THE BELT RAILWAY COMPANY OF CHICAGO

System General Order #2025-002

Effective 0001, September 19th, 2025.

Subject: System General Order #2025 - 002

9.1.3 RESTRICTING:

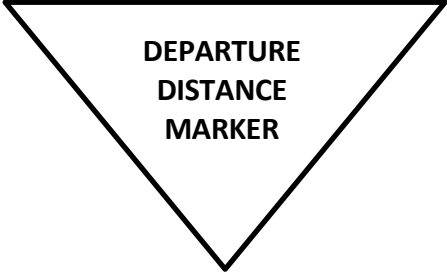
Aspects shown apply when displayed on a signal with, or without, a number plate.
